CITY PLAN COMMISSION**THURSDAY, SEPTEMBER 07, 2023****FILE NUMBER:** S223-226**SENIOR PLANNER:** Hema Sharma**LOCATION:** between Pennsylvania Avenue and Peabody Avenue, west of Harwood Street**DATE FILED:** August 10, 2023**ZONING:** PD 595 (Subdistrict D(A))**PD LINK:** <https://dallascityhall.com/departments/city-attorney/Articles/PDF/Article%20595.pdf>**CITY COUNCIL DISTRICT:** 7**SIZE OF REQUEST:** 0.9991 -acres**APPLICANT/OWNER:** Forest Forward

REQUEST: An application to replat a 0.9991-acre tract of land containing all of Lots 5, 6, 10, 11 and 12 in City Block 12/1158 and a portion of 15-foot abandoned alley to create one lot on property located between Pennsylvania Avenue and Peabody Avenue, west of Harwood Street.

PRELIMINARY PLAT

FOREST FORWARD ADDITION 4
LOT 1, BLOCK 7/1144
BEING A REPLAT OF ALL OF LOTS 5, 6, 10, 11.

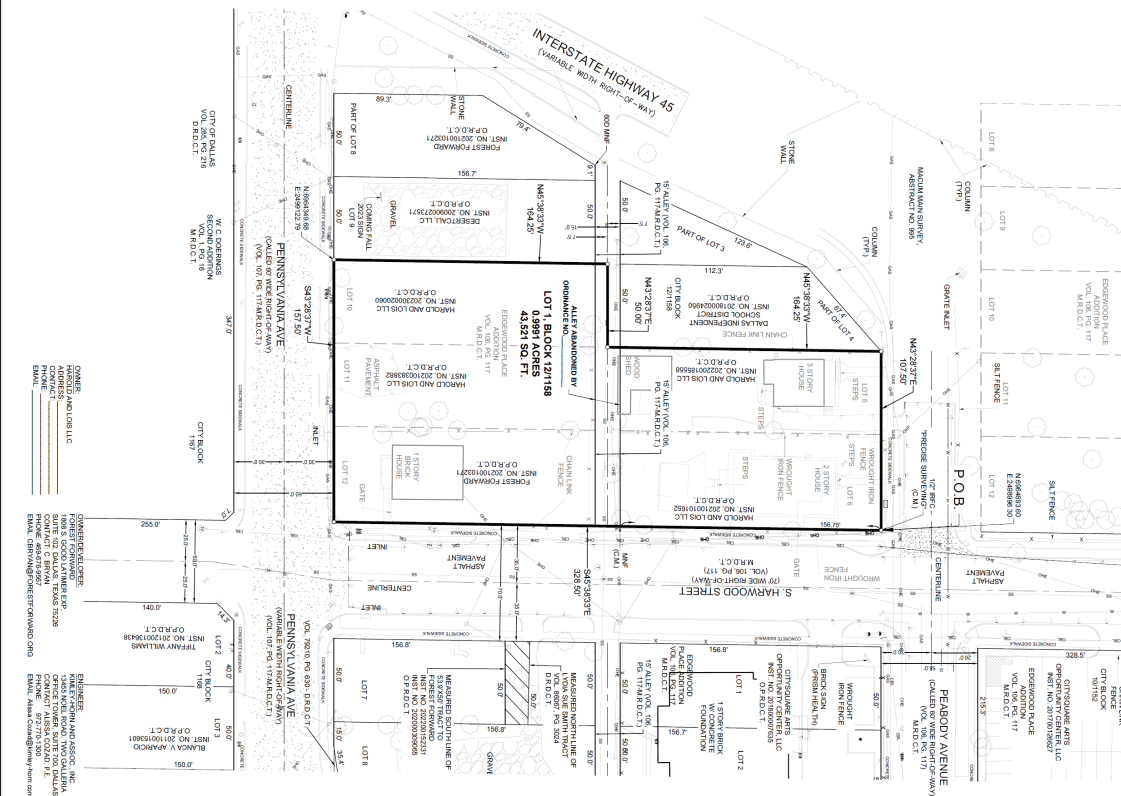
1. The final plat must conform to all requirements of the Dallas Development Code, Texas Local Government Code, Texas Land Surveying Practices Act and the General Rules and Regulations of the Texas Board of Land Surveying.

2. Department of Development Services, Engineering Division must verify that the plat conforms with the water, wastewater, and easement requirements under the provisions of Chapter 49 of the Dallas City Code.

3. Compliance with all plans, contracts, ordinances, and requirements of the City of Dallas. *Section 51A-8.102(a), (b), (c), and (d)*
4. The number and location of fire hydrants must comply with the Dallas Fire Code.

5. Any new or existing structure may not extend across new property lines. *Section 51A-8.503(e)*
6. On the final plat, all easement abandonments, and ROW abandonments must be by separate instrument with the recording information shown on the face of the

7. On the final plat, include two boundary corners tagged with these coordinates: "Texas State Plane Coordinate System, North Central Zone, North American Datum of 1983 on Grid Coordinate values, No Scale and no Projection."

8. On the final plat, monument all set corners per the Monumentation Ordinance. Prior to submittal of the final plat for the Chairman's signature. The monuments must be verified by the Chief City Surveyors Office in the Public Works Department. *Section 51A-8.617*

11. The number of lots permitted by this plat is one.

12. Submit a full set of Civil Engineering Plans (drainage, paving, street signage/markings/lighting) prepared per City Standards by a licensed (TX) Professional Engineer to Engineering Division in Room 200, Oak Cliff Municipal Center (i.e. 311T/DP). Additions and alterations to the public infrastructure require approval and may require private development contracts with bonds. 51A-8.102 (c); 8.601(b)(4),(5),(6),(7),(8),(9)
13. Detention may be required if the capacity of available outfall is not adequate to carry the developed runoff. Section 51A-8.611(c).
14. Place a note on the final plat stating "Lot-to-Lot drainage will not be allowed without proper City of Dallas Engineering Division approval" 51A 8.611(e)

15. On the final plat, dedicate a minimum 5-foot by 5-foot corner clip (via fee simple or street easement) at the intersection of Pennsylvania Avenue & Harwood Street. Section 51A 8.602(d)(1)
16. On the final plat, dedicate a minimum 5-foot by 5-foot corner clip (via fee simple or street easement) at the intersection of Peabody Avenue & Harwood Street. Section 51A 8.602(d)(1)
17. Provide a turn-around per the City of Dallas Standards at the end of alley between Harwood Street and Service Road on West Side *Section 51A-8.506(b)*
18. Must coordinate with Transportation Department for any traffic signal requirements that are deemed necessary for improving pedestrian accessibility

22. Engineer must furnish plans for water and sanitary sewer. Developer must furnish a contract for water and sanitary sewer. Sections 49-60(g)(1) and (2) and 49-62(b), (c), and (f).
23. Additional design information is required for assessment. Site plan must be submitted showing proposed development, building finished floor elevation, development, existing mains – including downstream manhole, and proposed water and wastewater service locations. Submit water/wastewater engineering plans to 320 E. Jefferson Blvd., Room 200, Attention: Water and Wastewater Engineering.
24. Water and Wastewater main improvements is required by Private Development Contract. Submit water/wastewater engineering plans to 320 E. Jefferson Blvd., Room 200, Attention: Water and Wastewater Engineering.

25. On the final plat, please remove fence in right of way on Peabody Avenue. Please show the alley abandonment on the plat as follows: Abandonment authorized by Ordinance No. _____, recorded as Inst. Nos. (Cert. ORD No. _____, QCD No. _____). Utility Easements retained.
26. On the final plat, change “Pennsylvania Ave” to “Pennsylvania Avenue”/ Change “S Hardwood Street” to “Harwood ST” / Change “Interstate Highway 45” to “Julius Schepps Freeway/Interstate Highway No. 45”.
27. On the final plat, identify the property as Lot 5A in City Block 12/1158. Ordinance 1A, Page 131 pages 131-148, Section 2 (passed August 13, 1872).
